Section 16 Planning Application for Proposed Mixed-Use Development (Proposed Flat with Permitted Commercial Uses) with Minor Relaxation of Building Height Restriction at Lot 4354 in D.D. 124, Kiu Tau Wai, Yuen Long (Application No. A/HSK/617)

Response to Departmental Comments

GENERAL LAYOUT PLAN R/F

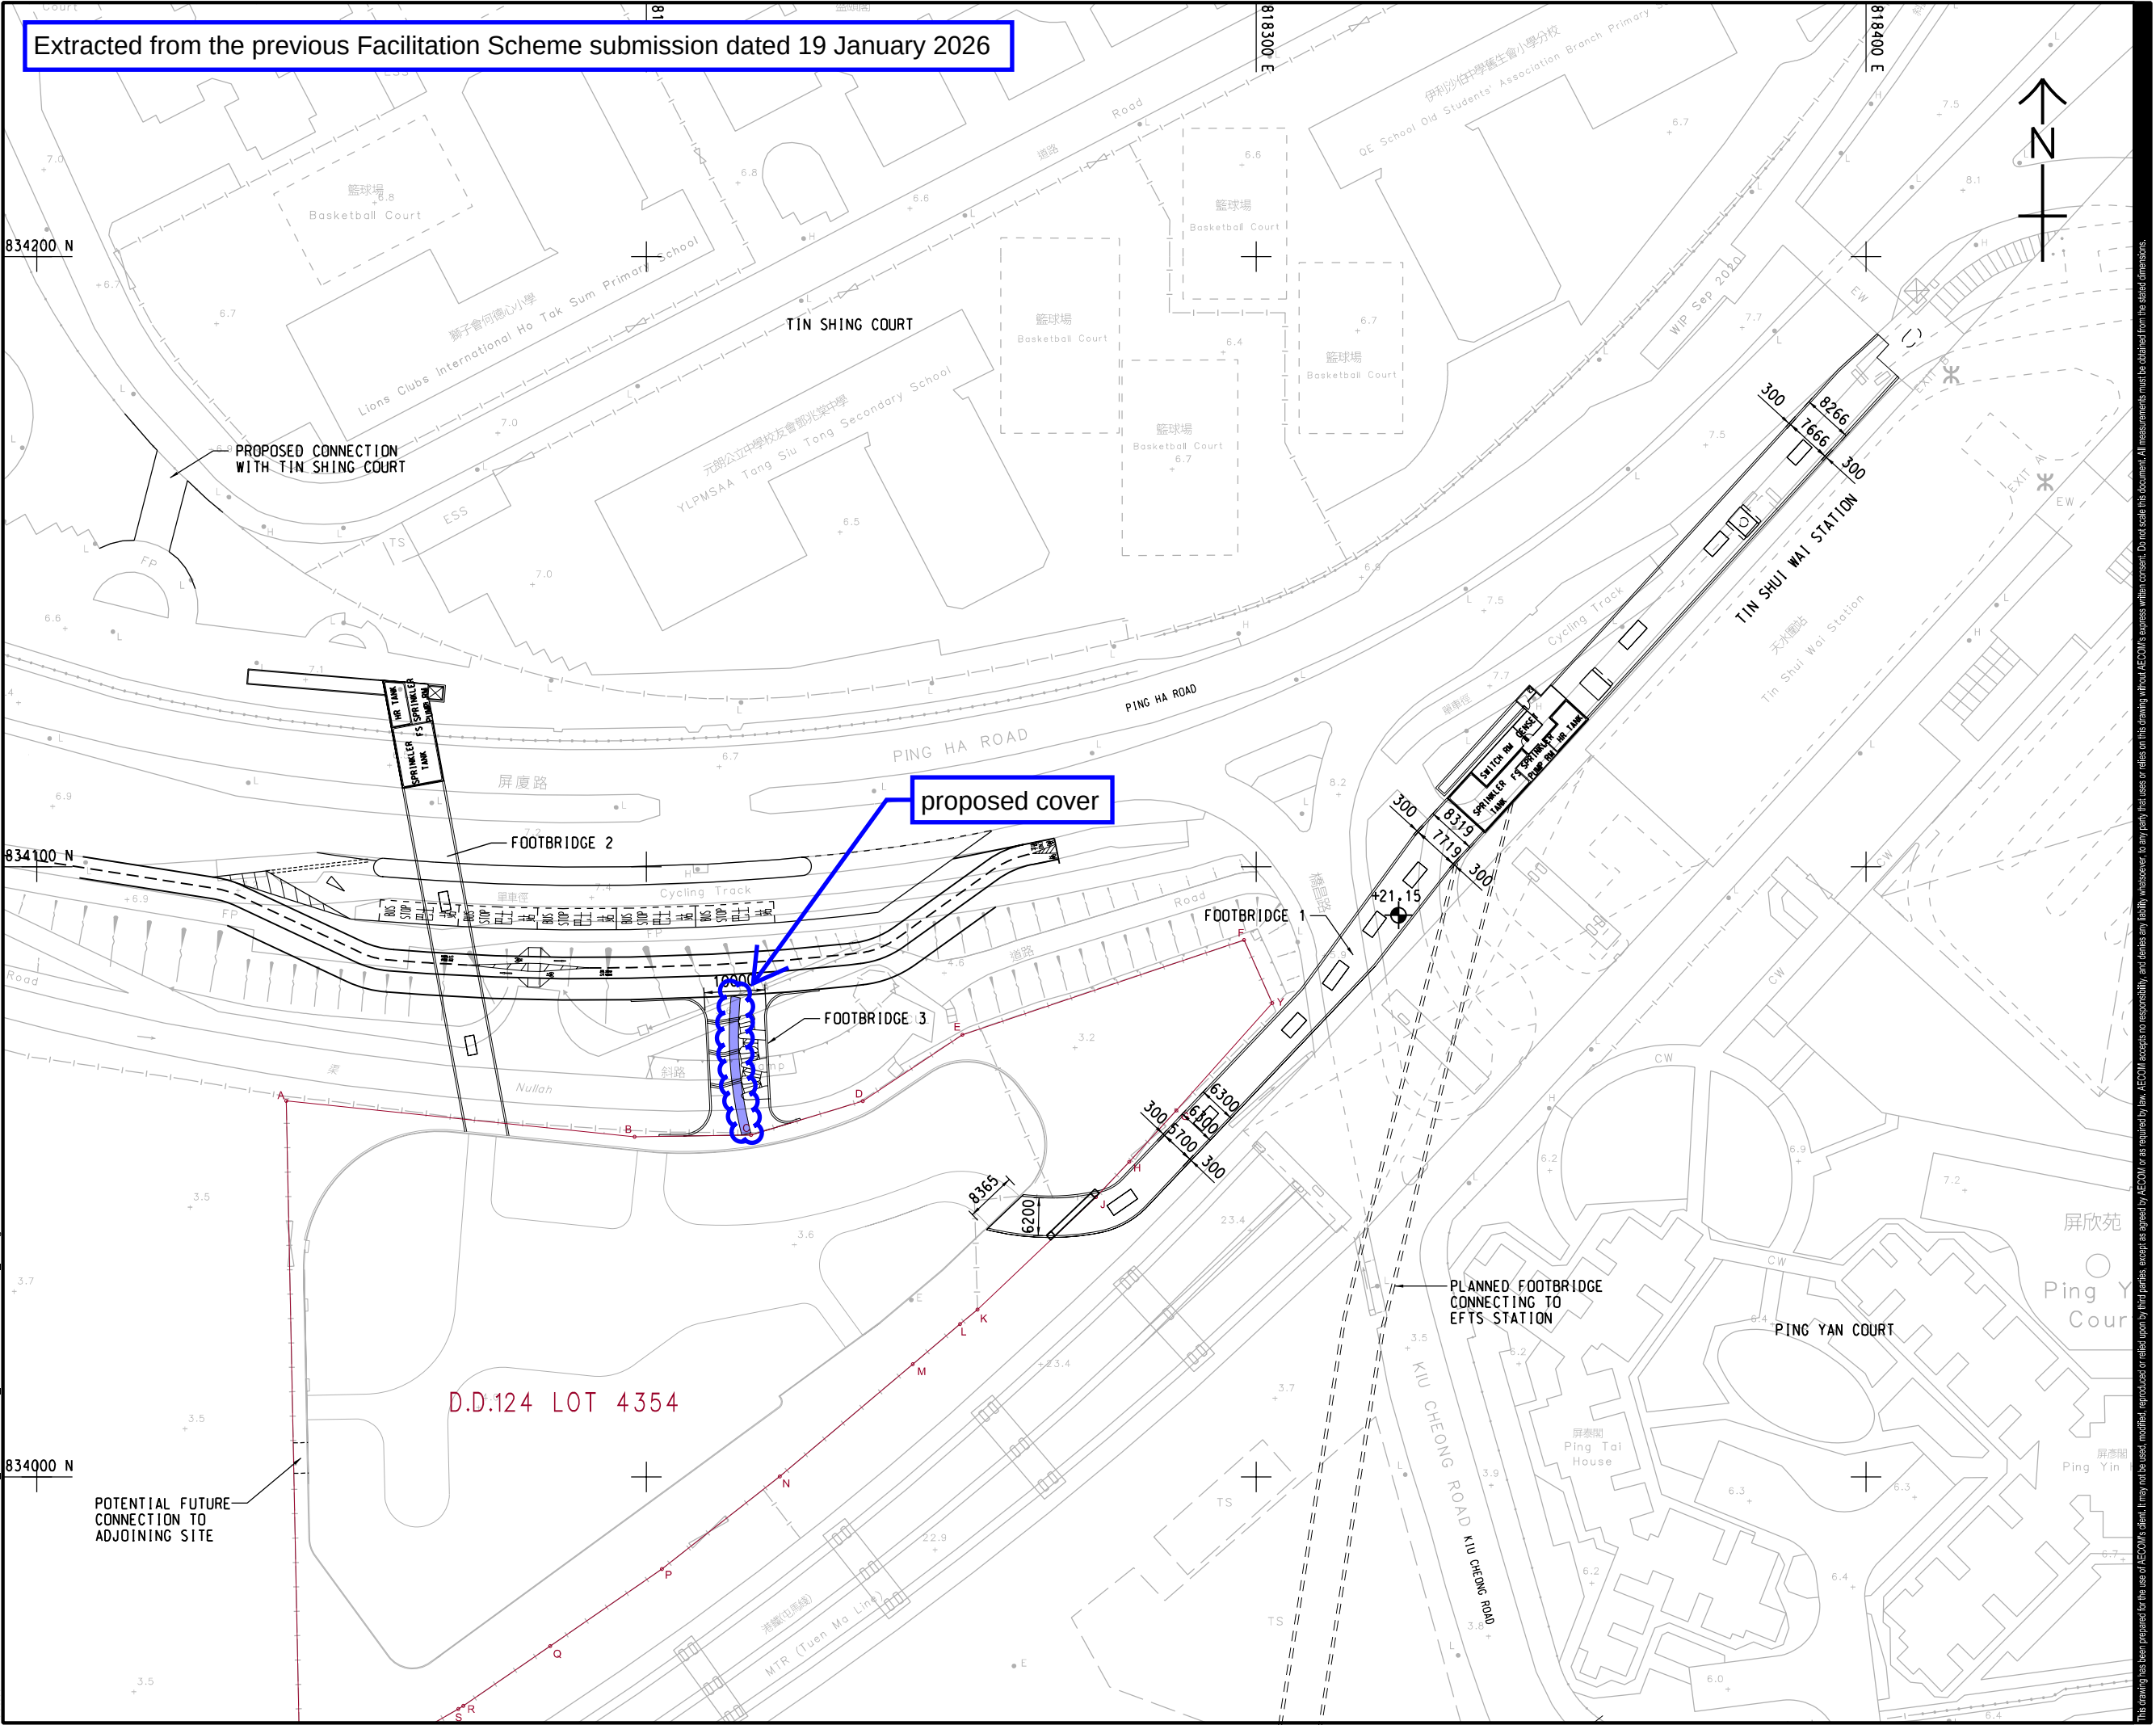
Departmental Comments	Responses to Comments
2.3	FB2: The proposed footbridge connecting the subject lot to Ping Ha Road over the existing nullah has been included in the Facilitation Scheme application. However, the proposed covered walkway (as shown in the Indicative Master Layout Plan in P. 28 of the Planning Statement) has not been included in the application under the Facilitation Scheme. The Applicant is required to clarify the differences and advise whether the proposed covered walkway will form part of the application under the Facilitation Scheme. As revealed from the R-to-C in the s.16 submission, it is noted that the applicant has provided the response “Please be clarified that the proposed covered walkway has been included in the application under the Facilitation Scheme.” However, the applicant may wish to clarify which application under the Facilitation Scheme has contained such proposed covered walkway.	The Applicant would like to clarify that, a cover for the footbridge connecting the subject site to Ping Ha Road over the existing nullah was included under a previous Facilitation Scheme submission dated 19 January 2026 to your office. Please refer to the extract of the submission in Annex A of this RtoC table with the location of cover indicated for your reference. Nonetheless, upon further review of design, the extent and alignment of the cover has been adjusted and extended to cover the area along the proposed bus layby along Ping Ha Road as well as indicated in Figure 3.2 in the Planning Statement submitted to the Board on 8 June 2026. The latest alignment and extent of the proposed covered walkway will be reflected accordingly in subsequent application under the Facilitation Scheme.

Drawing No.
FIGURE 3.2

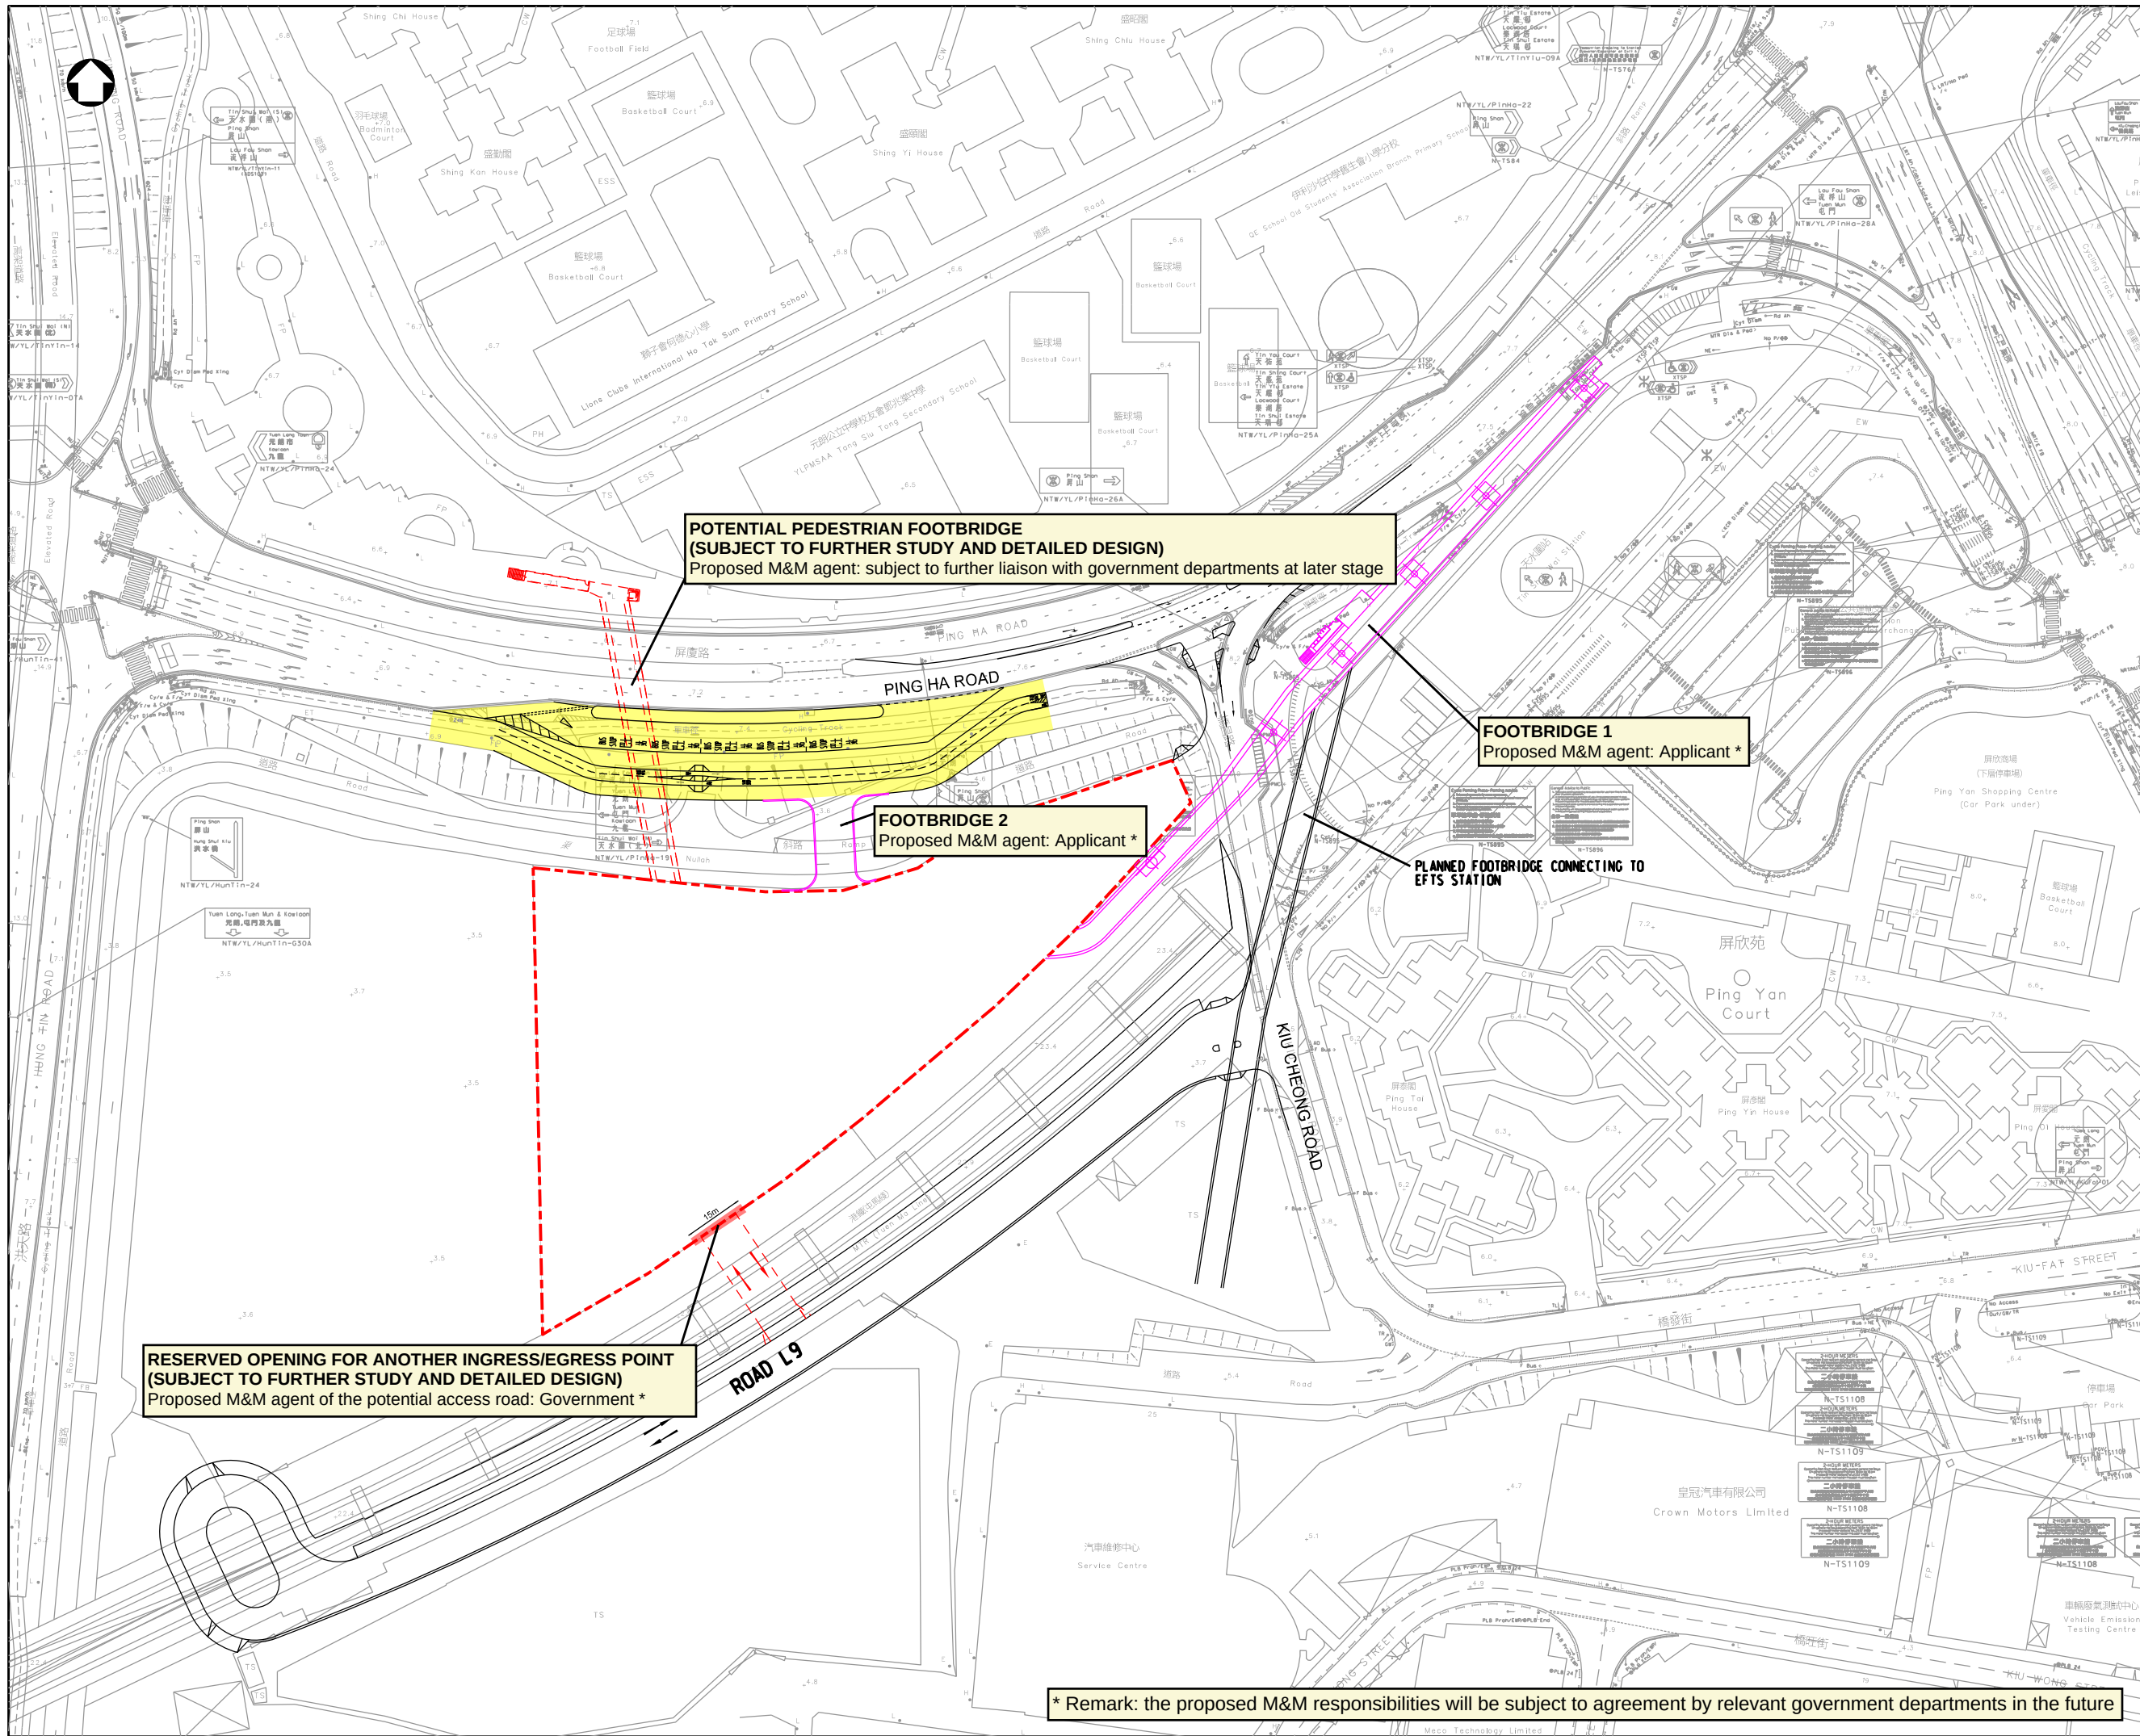
8.6	Figure 3.2: for the access road connecting to the proposed Road L9. The road width shall be widened to facilitate both the access of residential parking spaces and queuing of visitors' parking spaces.	Noted. The road width has been widened as shown in Figure 3.2 of the TIA replacement pages under Attachment 3 accordingly to facilitate both the access of residential parking spaces and queuing of visitors' parking spaces.

8.7	Figure 3.2: please indicate the proposed column location for the proposed bridge structures.	Noted. The proposed column location has been indicated in Figure 3.2 of the TIA replacement pages under Attachment 3 accordingly.
